# Additional Information

Ray Westall Operating, Inc.  
**Greenwood Federal SWD #1 - C-108**  
**Action ID: 102781 – C-108 submitted April 2022.**

***Amendment Items Requested by OCD June 2023***  
***Current Status: Application is in queue for admin review.***

## Log Cross-Section for San Andres/ Delaware Target Interval

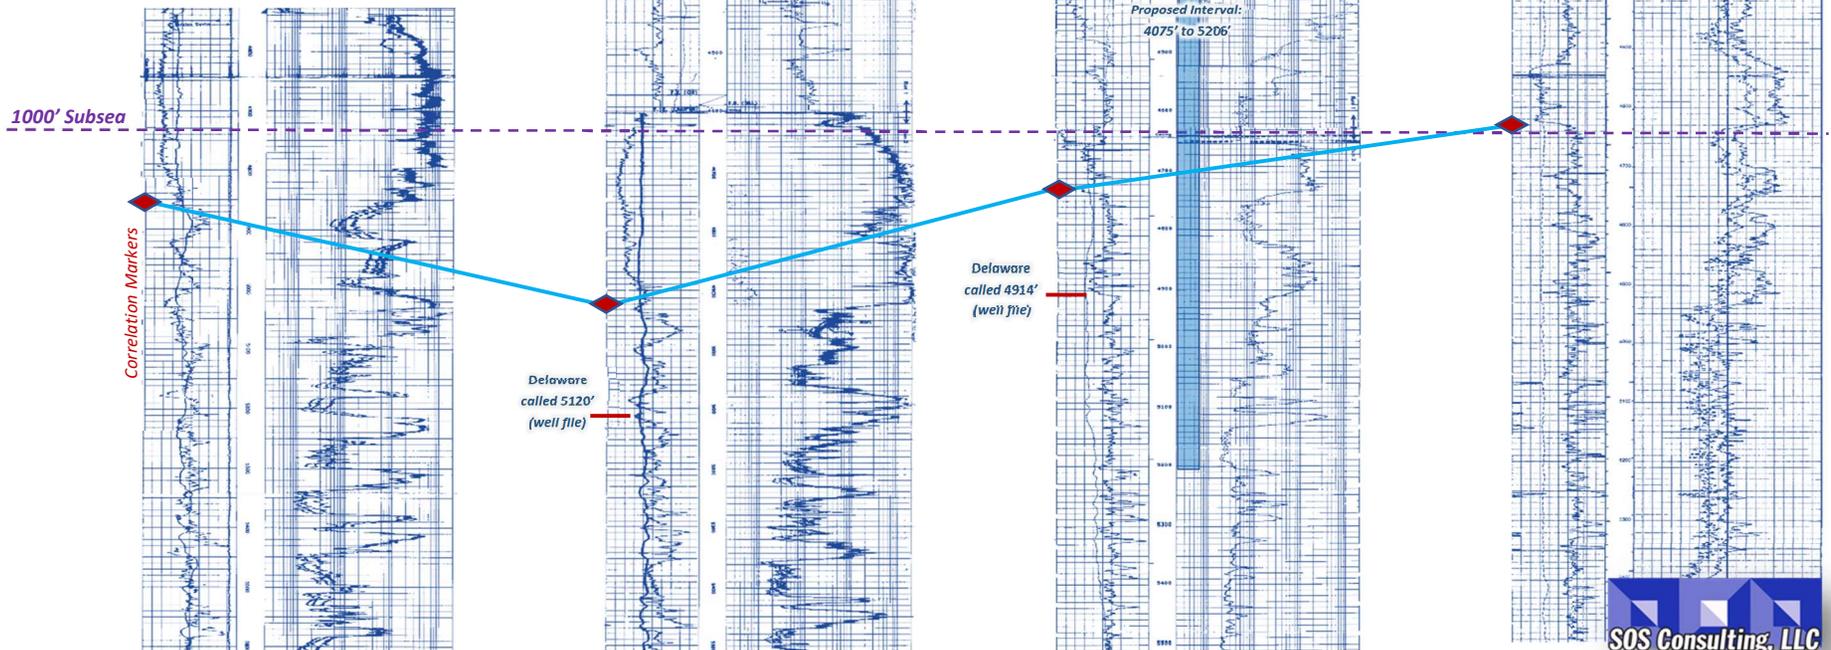
- Need a little more correlation work on the stratigraphic units. Delaware doesn't mean much as this is a DMG –SA transition that represents an unconformity. Could be confining or could be a conduit. So what is the lower confining layer or zone?  
*The proposed pool (SWD; San Andres-Delaware, Pool ID #96125) is an OCD designated pool. See attached log cross-section and additional geologic description. RWO will run annual radioactive tracer/ temperature logs for 5 years to ensure fluid is not migrating or communicating below intended interval. If injectate placement is appropriate for 3 years, tracer logs could be scheduled for every-other or every 3<sup>rd</sup> year.*

*RWO believes there is little risk of upward migration through injection into the lower portion of the San Andres interval. The log cross-section shows low porosity above the requested zone and the last CBL confirms good cement above the interval.*

Logs from 3 offsetting wells were reviewed and correlated with the subject interval as goal. Based on the correlation, RWO, Inc. is targeting an overall injection interval from approximately 4075 feet to 5206 feet. Specific selectively perforated intervals will be determined upon further log analyses.

# WELL SCHEMATIC - CURRENT Greenwood Federal SWD Well No.1

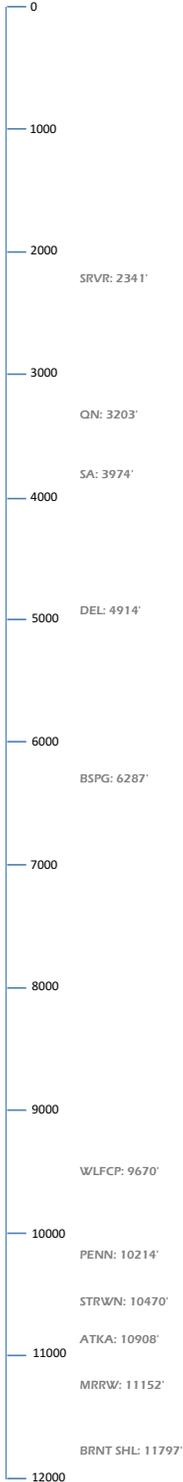
- No wellbore diagram of the current well.  
*Attached.*
- Issues with the plugback; should be a plug at the top of Wolfcamp and one for the top of Bone Spring.  
*Attached. Proposed Wellbore Diagram revised to show appropriate plugs between zones.*

### WELL SCHEMATIC - PROPOSED Greenwood Federal SWD Well No.1

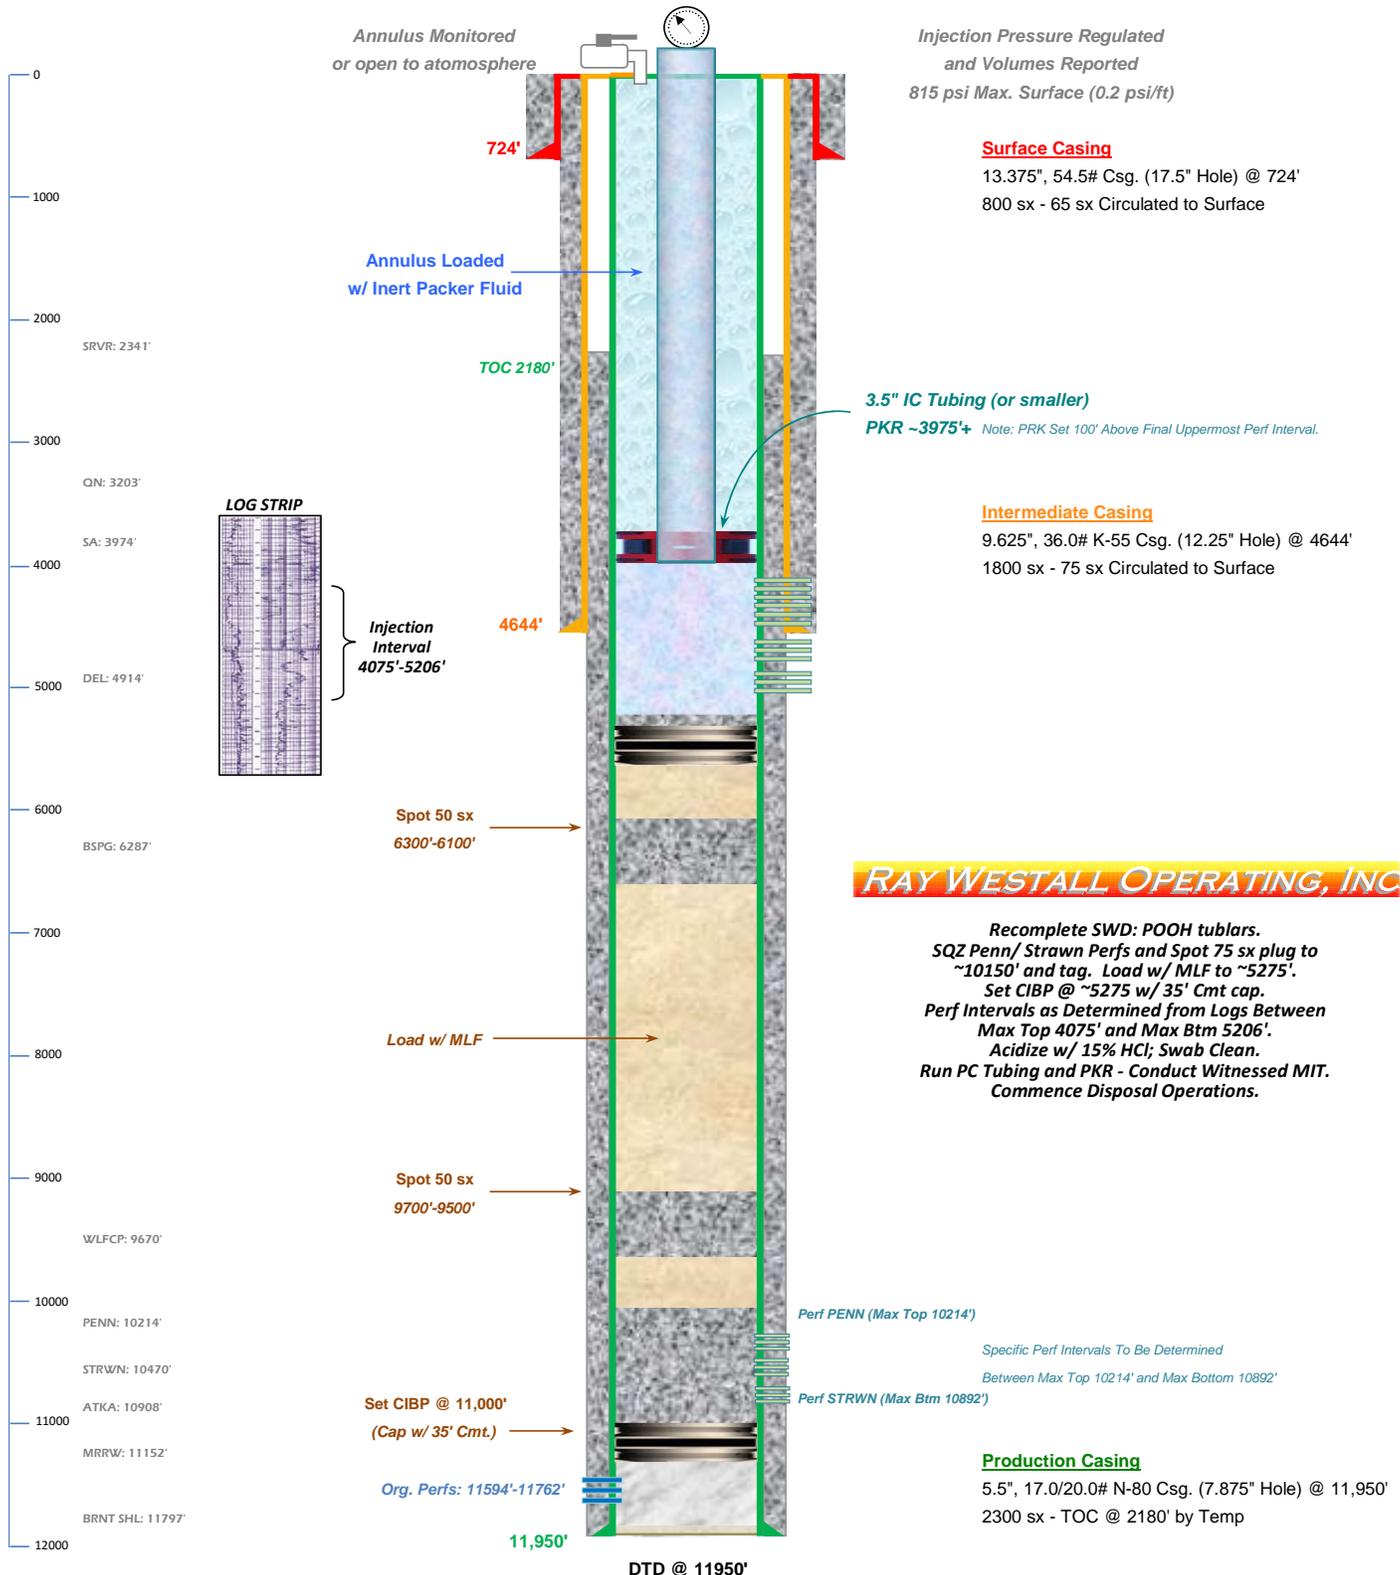
- The proposed perforations are to go through both the intermediate and production casing. What placement are proposed the perms for around the shoe of the intermediate casing such the shoe is not compromised?  
*Ray Westall Operating will not perforate within 3 feet above or below the casing shoe depth.*

**Recomplete SWD: POOH tublars.**  
SQZ Penn/ Strawn Perfs and Spot 75 sx plug to ~10150' and tag. Load w/ MLF to ~5275'.  
Set CIBP @ ~5275 w/ 35' Cmt cap.  
Perf Intervals as Determined from Logs Between Max Top 4075' and Max Btm 5206'.  
Acidize w/ 15% HCl; Swab Clean.  
Run PC Tubing and PKR - Conduct Witnessed MIT.  
Commence Disposal Operations.
